CMB Meeting Minutes #156

REFERENCE Project No. M544.1, Contract No. 149 Task 1-8.02

SUBJECT: Configuration Management Board Meeting # 156– Rev. No. 0

Proposed Location
for (N) Fire Hydrant

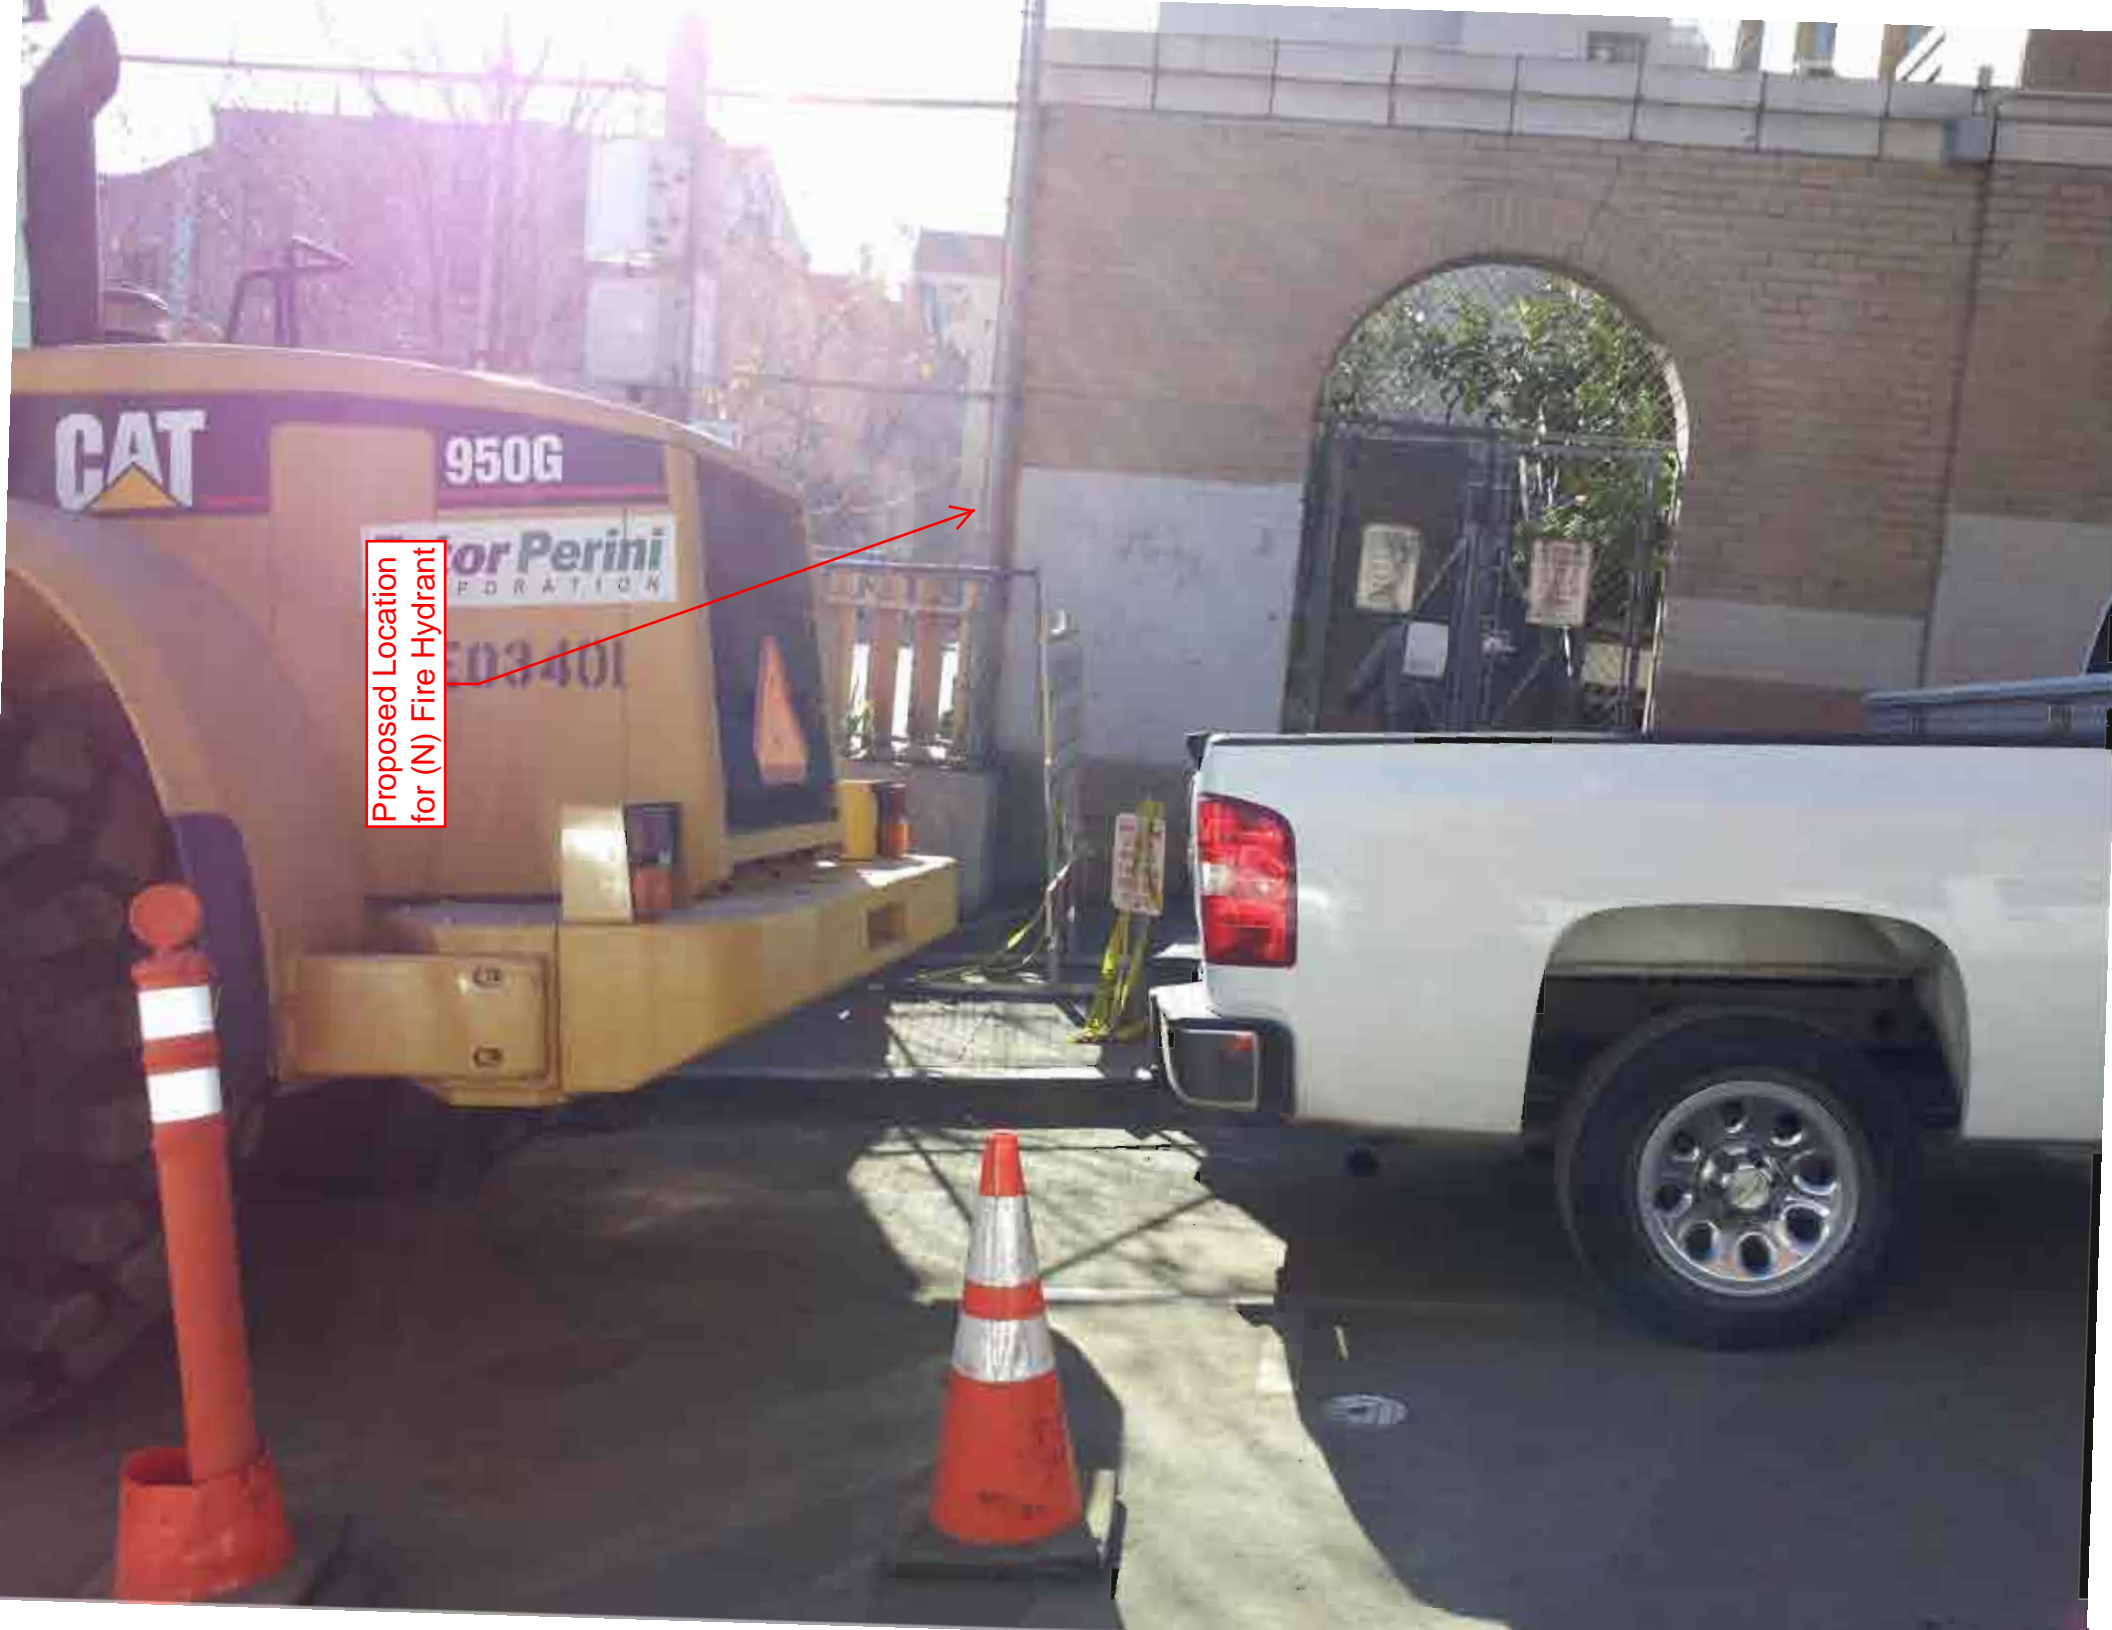
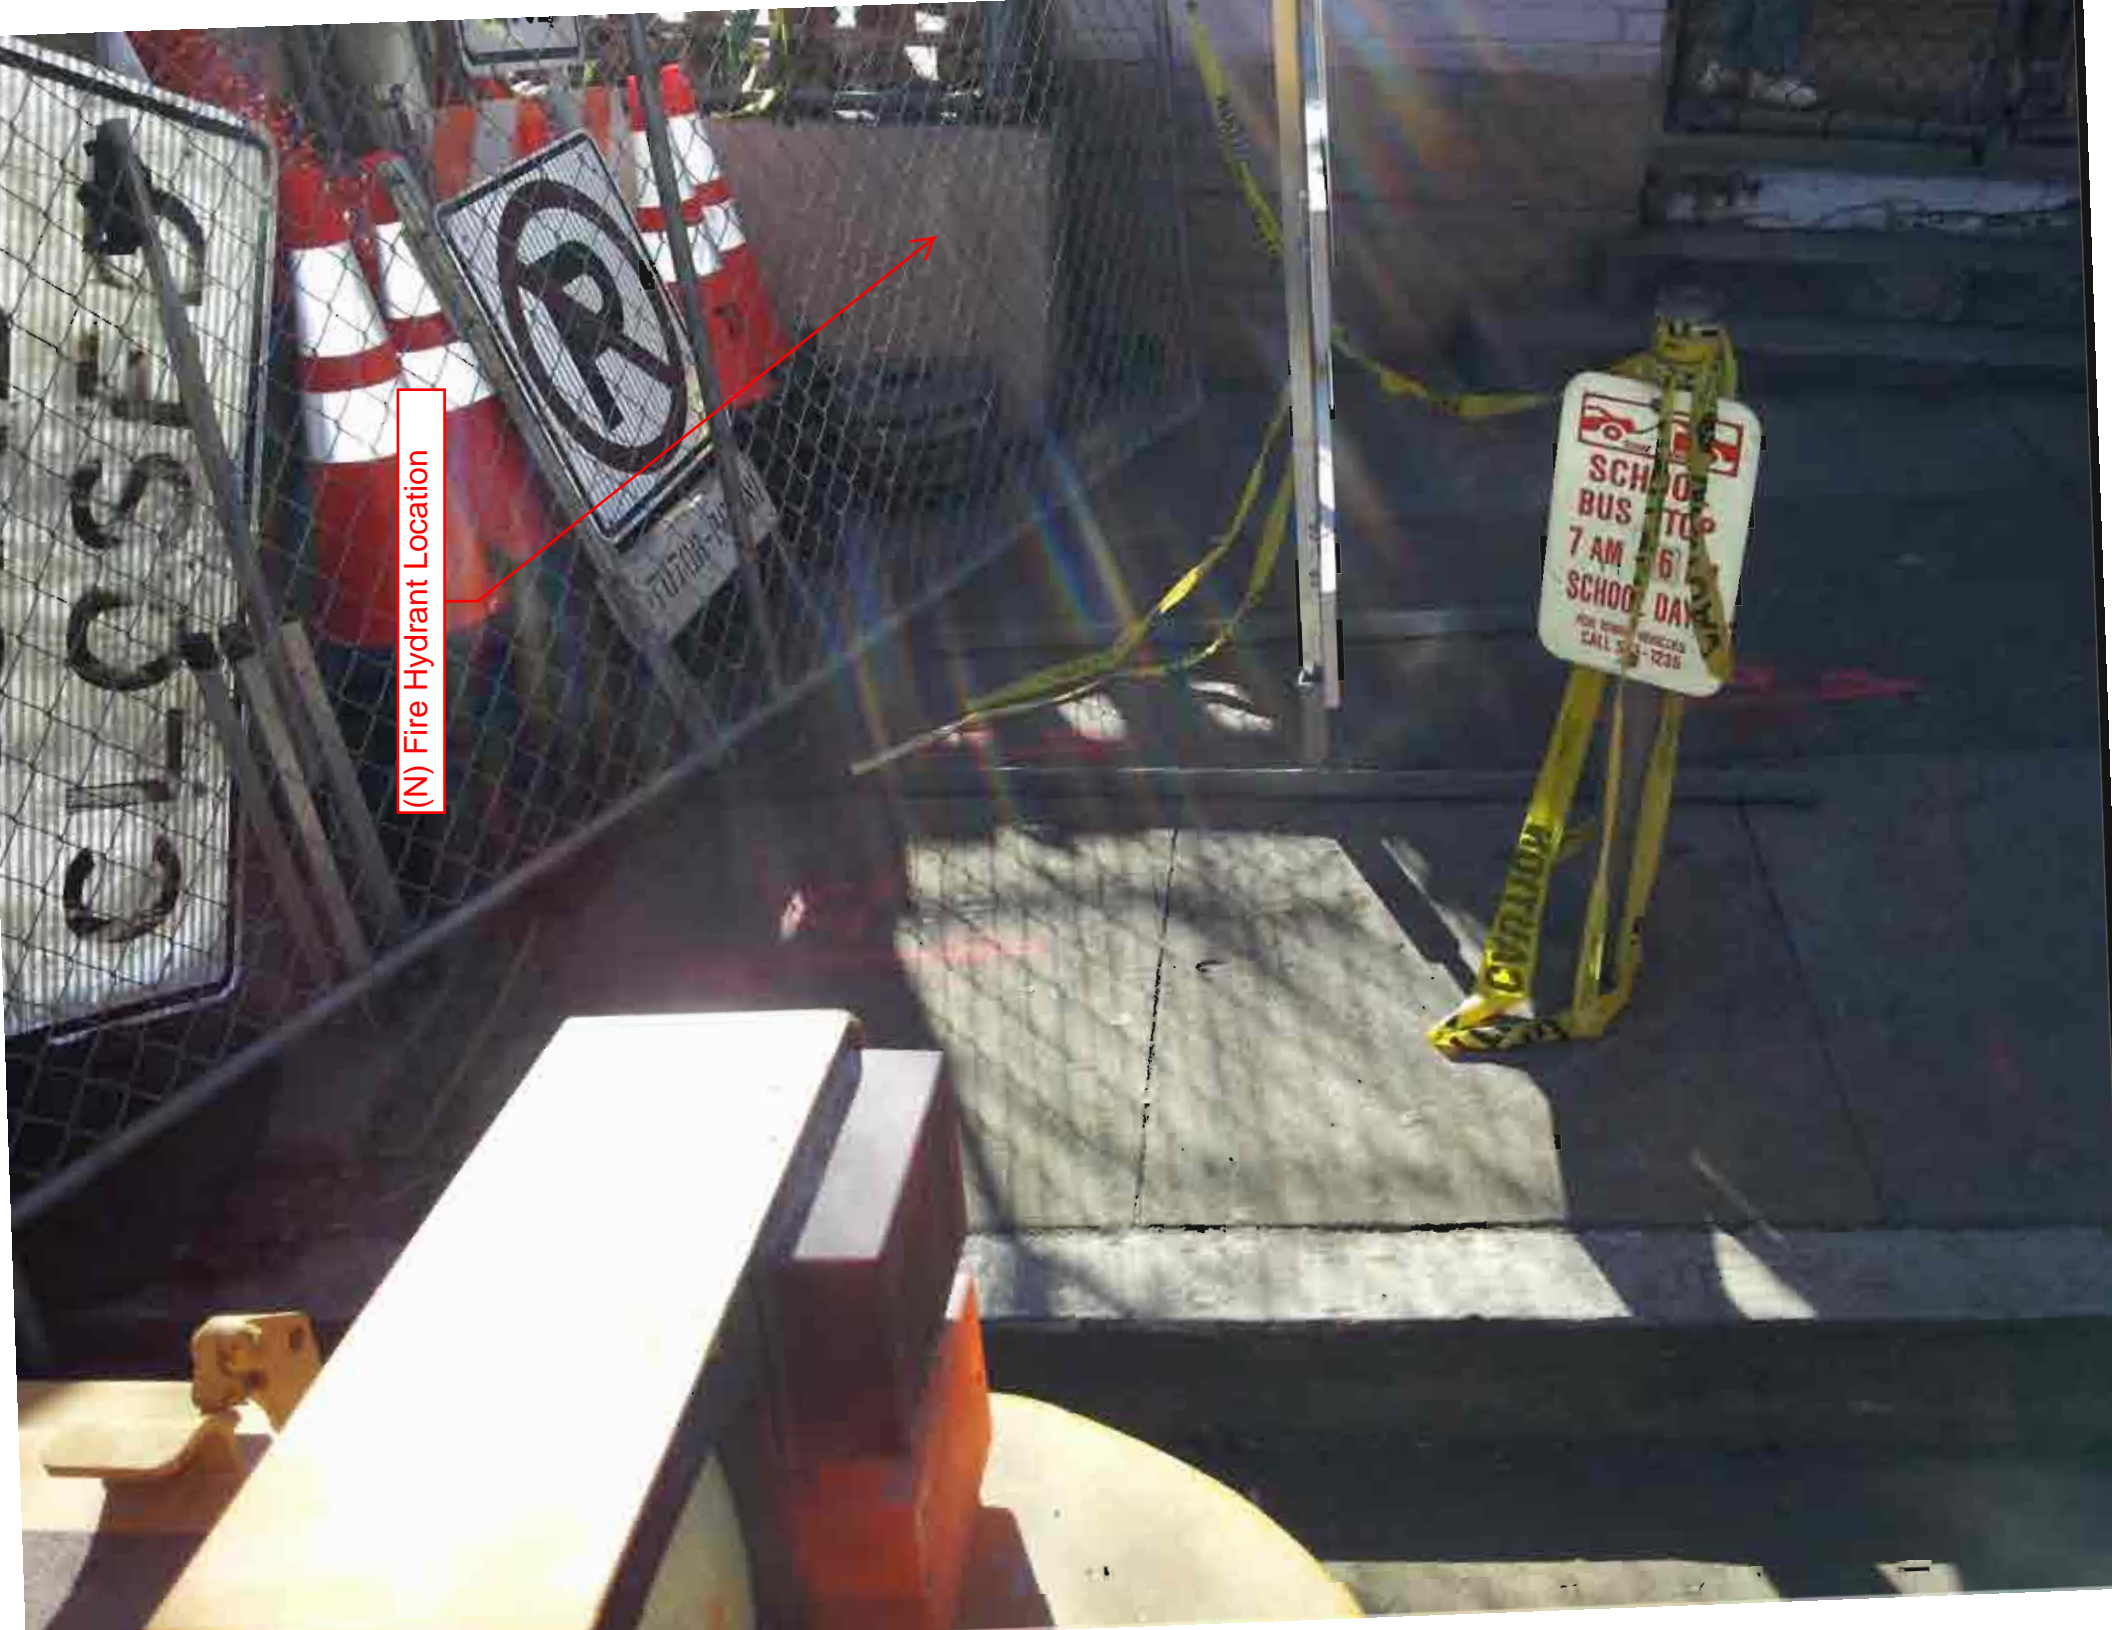
An unknown underground tank was discovered during excavation work for the installation of the new fire hydrant along the Southern sidewalk of Washington Street, shown on Drawing No. AW-201.4.

At approximately 7' East of new fire hydrant location, shown on Drawing No. AW-201.4, demo existing sidewalk along the South side of Washington Street and excavate to a depth of 6' to confirm potential location of new fire hydrant is feasible.
